HERITAGE COMMITTEE AGENDA

TO: Committee Members
FROM: Karin Albert, Senior Planner
SUBJECT: Request for Comment on Heritage Alteration Permit Amendment and Development Variance – 2714 Dunsmuir Avenue

2714 DUNSMUIR, CUMBERLAND

HERITAGE ALTERATION PERMIT AMENDMENT COMPARISON TO PREVIOUS DESIGN

OVERLAY OF NEW BUILDING

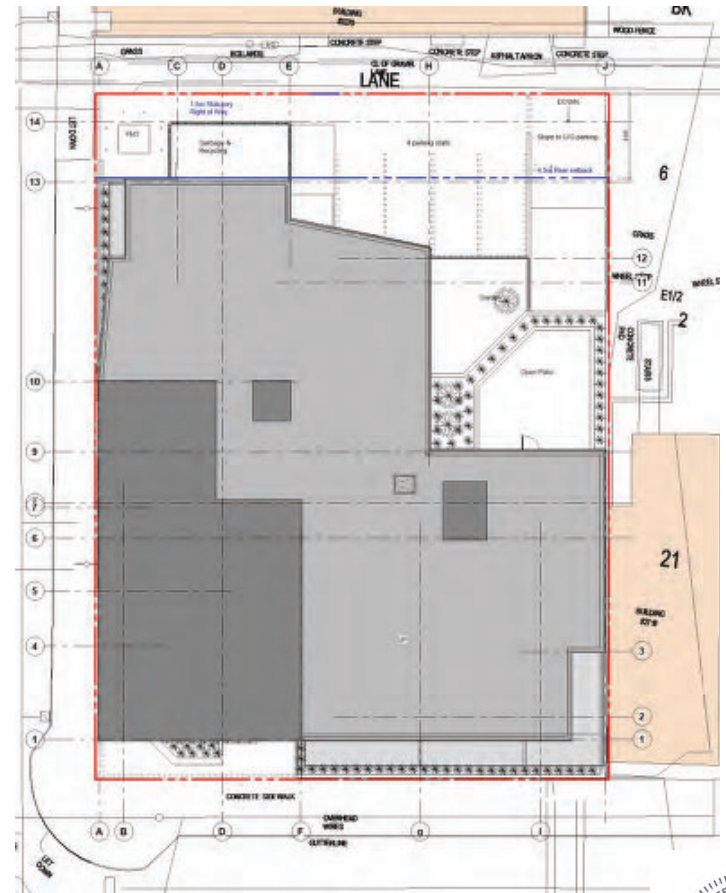
- 1/ WITH RESPECT TO THE ORIGINAL DP DESIGN THE MASSING OF THE BUILDING HAS BEEN AMENDED DUE TO AN ELECTRICAL SETBACK (3M FROM POWER LINES)
- 2/ THE CORNER MASSING HAS BEEN RECESSED BY 2.06M

- 3/ THE LOT COVERAGE REMAIN IDENTICAL (68%) AND THE DENSITY HAS BEEN INCREASED TO FSR : 2.0
- 4/ THE RESIDENTIAL ENTRANCE HAS BEEN REDUCED IN SIZE AND CHANGED THE 2 STAIRS INTO A SCISSOR STAIR THAT REQUIRES LESS FLOOR AREA

- 5/ THE CLADDING MATERIALS HAVE BEEN CHANGED DUE TO A CODE REQUIREMENT TO HAVE A NON-COMBUSTIBLE CLADDING ON THE INTERIOR LOT LINE. THE EXISTING COMBUSTIBLE CHARRED-LOOK WOOD VERTICALLY INSTALLED SIDING HAS BEEN REPLACED BY A NON-COMBUSTIBLE BLACK CORRUGATED METAL PANEL, VERTICALLY INSTALLED.

MAIN FLOOR PLAN

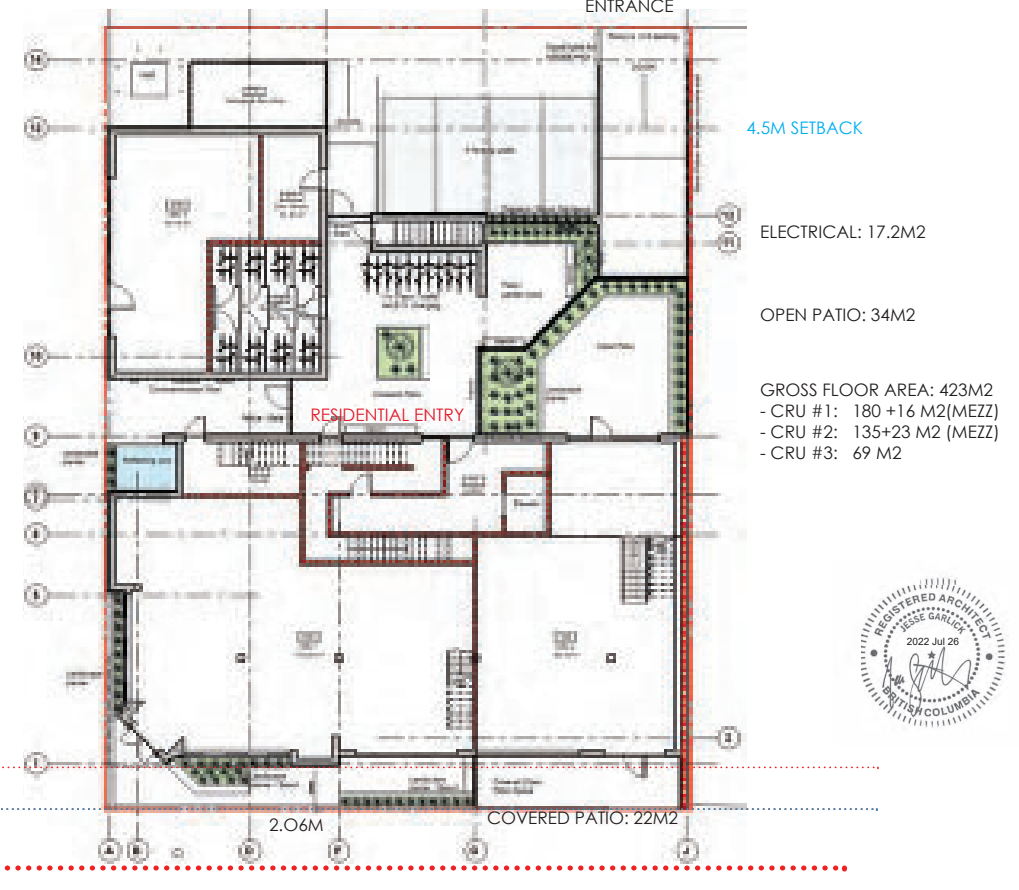
SETBACK DUE TO HYDRO LINE
 SINGLE RESIDENTIAL MAIN ENTRANCE IN COURTYARD

FRONT SETBACK:
 - REQUIRED: MIN. 0M
 MAX 1.0M FOR A MIN OF 75 % OF THE BUILDING FACADE
 - PROPOSED: 0-2.06M **

ROOF PLAN

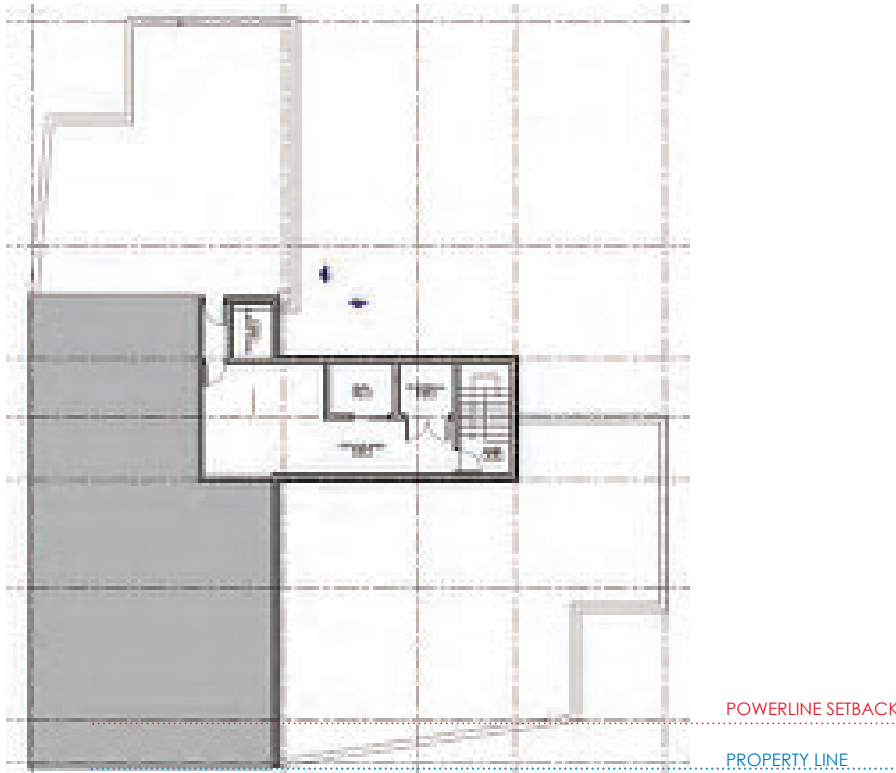
FLOOR AREA AS BEEN REDUCED TO ONLY THE SLOPED ROOF, MECHANICAL SHAFT AND THE ELEVATOR OVERRUN. ROOF IS ACCESSIBLE BY LADDER WITH ROOF HATCH

BASEMENT PLAN

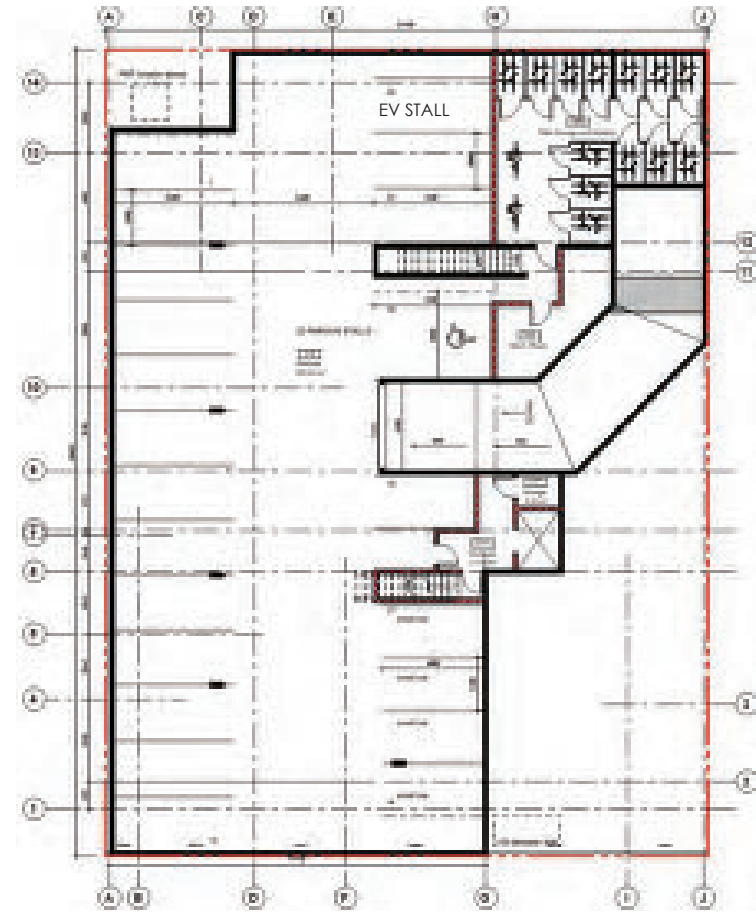
PERSONAL BIKE STORAGE

FULLY UNDERGROUND PARKADE WITH 22 CAR STALLS / MECHANICAL ROOM / BIKE STORAGE & AMENITY

ELEVATIONS

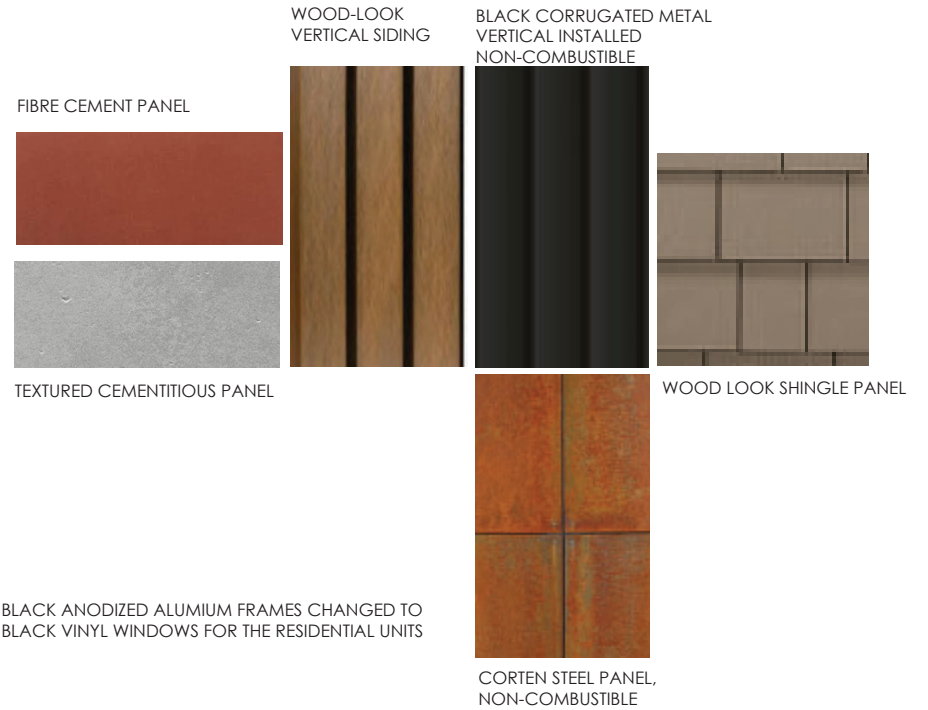
BLACK ANODIZED ALUMINIUM FRAMES CHANGED TO BLACK VINYL WINDOWS FOR THE RESIDENTIAL UNITS

- CLADDING CHANGED TO SHINGLES INSTEAD OF VERTICAL SLATS
- CHARRED WOOD LOOK VERTICAL SIDING CHANGED TO BLACK CORRUGATED METAL, VERTICAL INSTALLED
- BLACK ANODIZED ALUMIUM FRAMES CHANGED TO BLACK VINYL WINDOWS FOR THE RESIDENTIAL UNITS

SITE PLAN

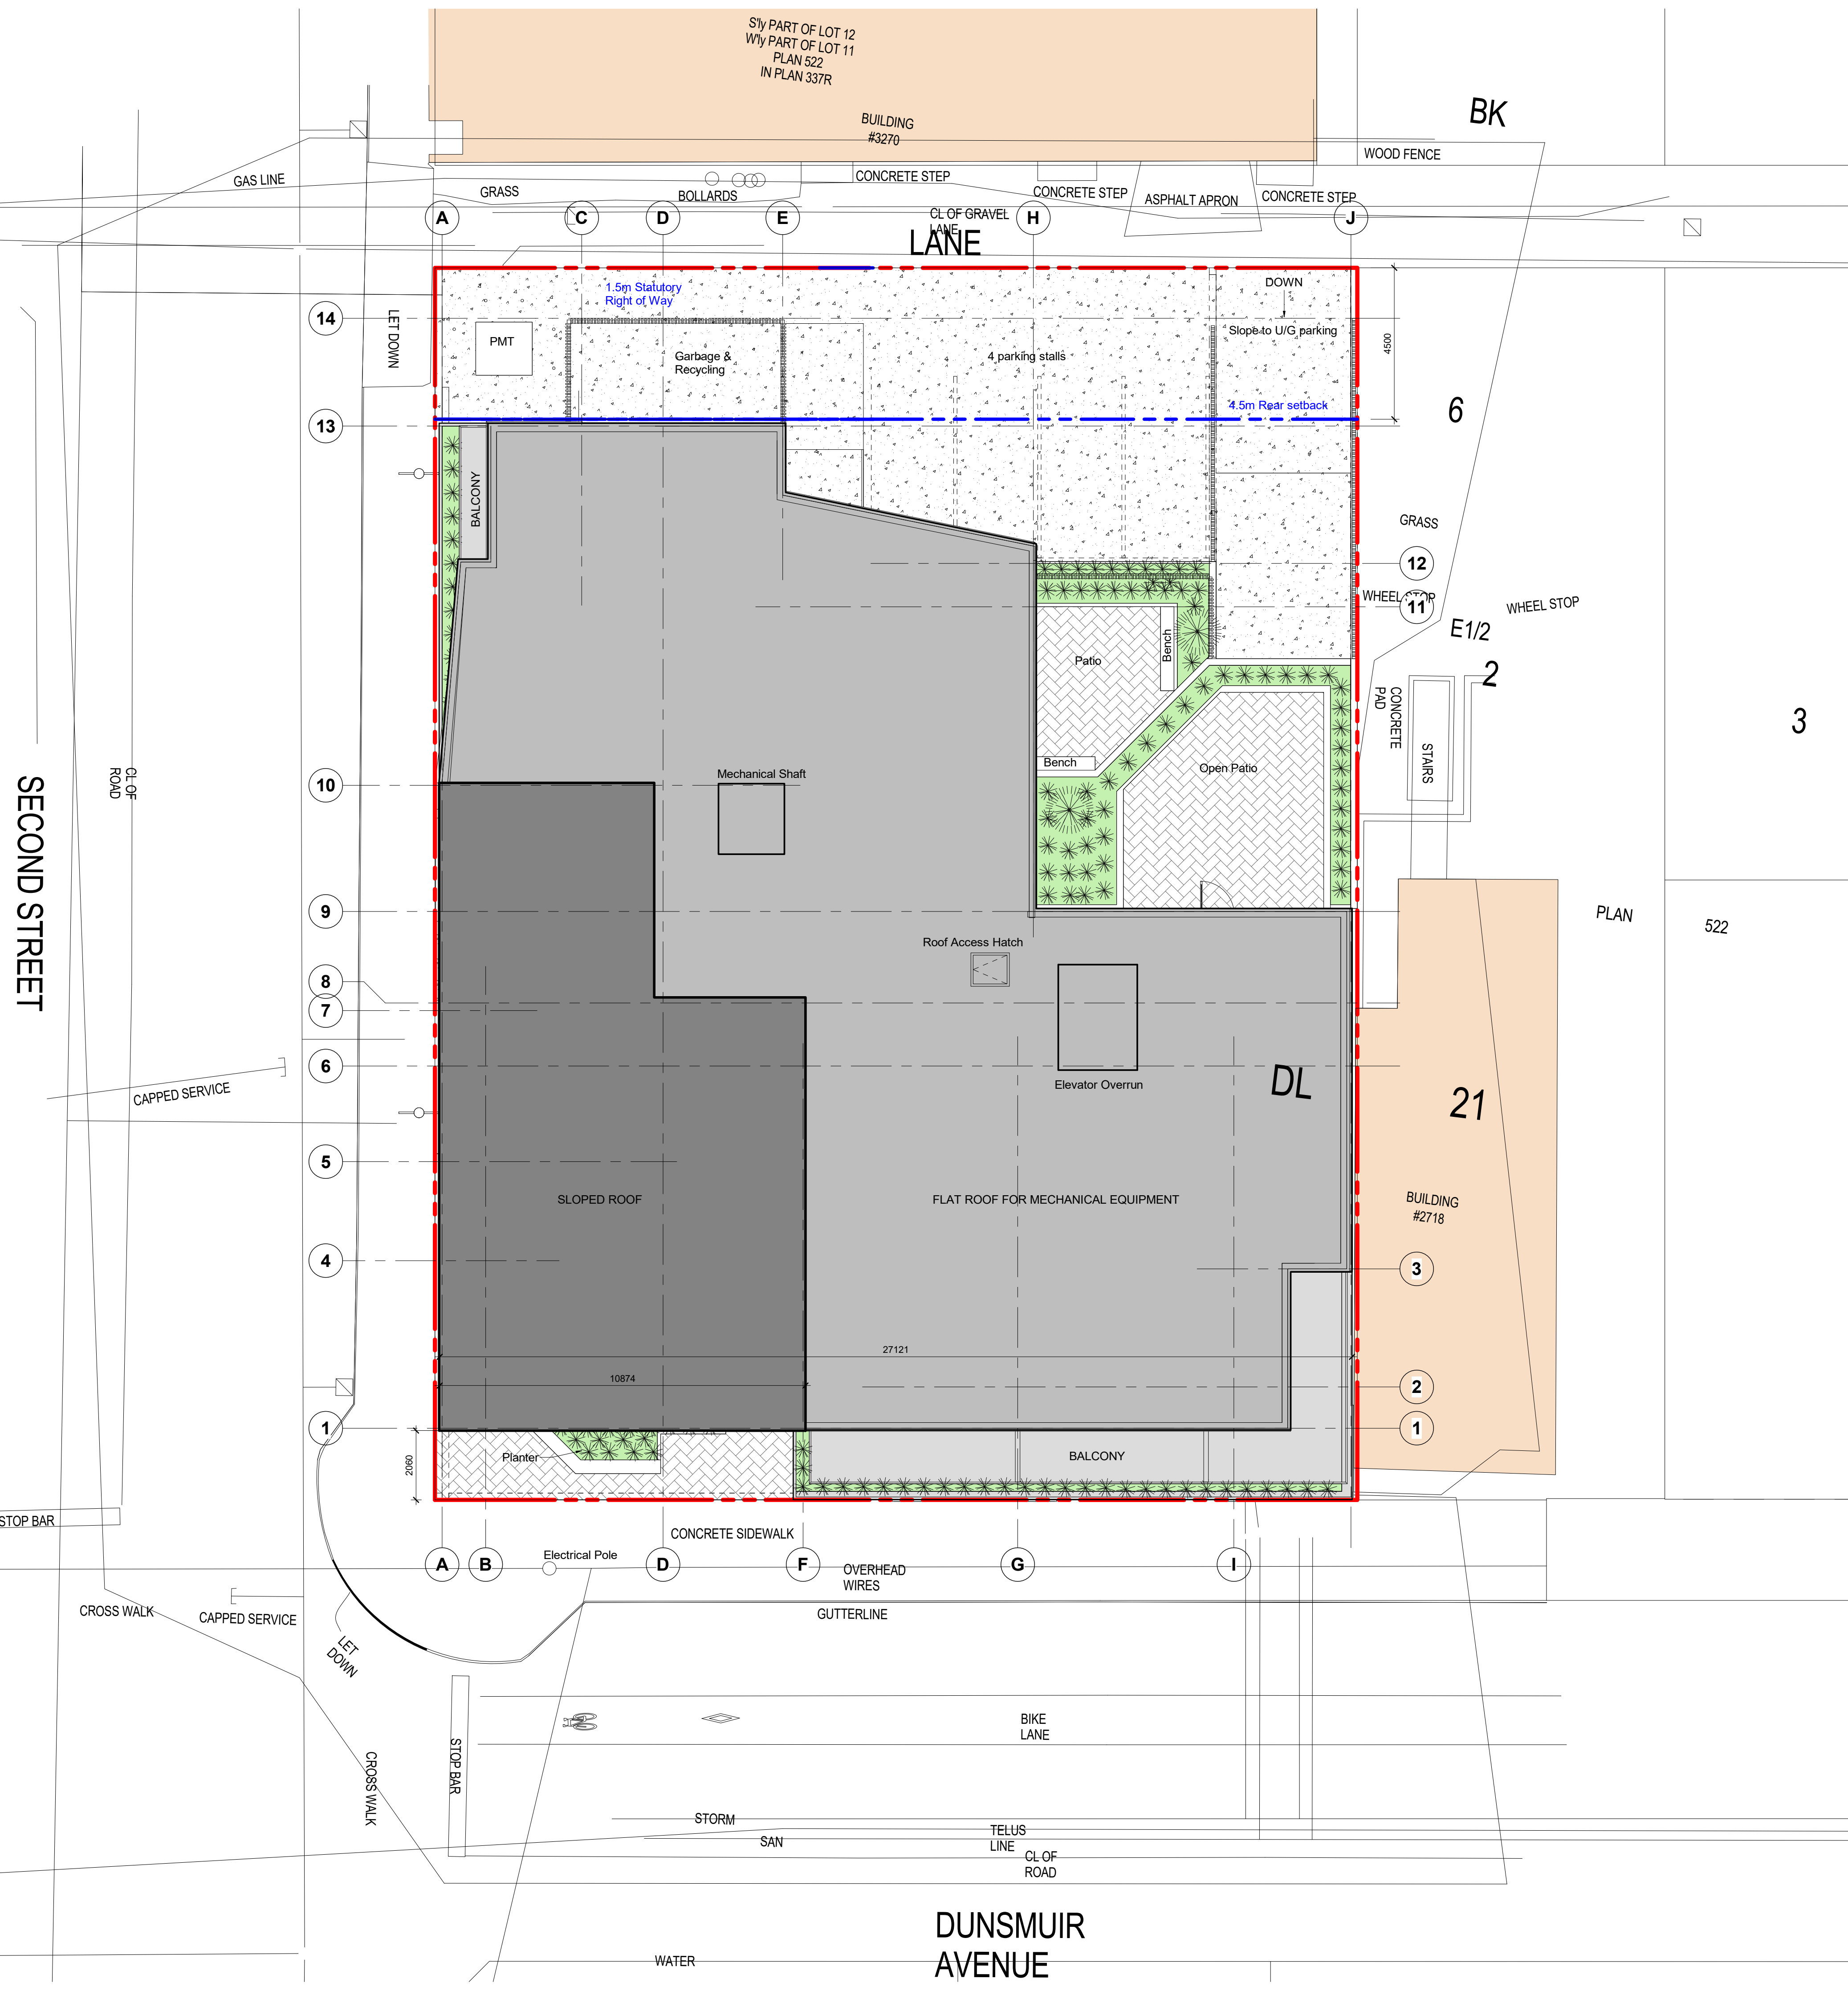
A VARIANCE IS REQUESTED FOR THE FRONT LINE SETBACK DUE TO THE LOCATION OF A ELECTRICAL POLE ON THE CORNER OF DUNSMUIR AND 2ND STREET. BY CODE, THE BUILDING NEEDS TO HAVE A 3M SETBACK FROM THE NEAREST POWERLINE. A FRONT SETBACK OF 2.06M IS REQUIRED TO BE CODE COMPLIANT
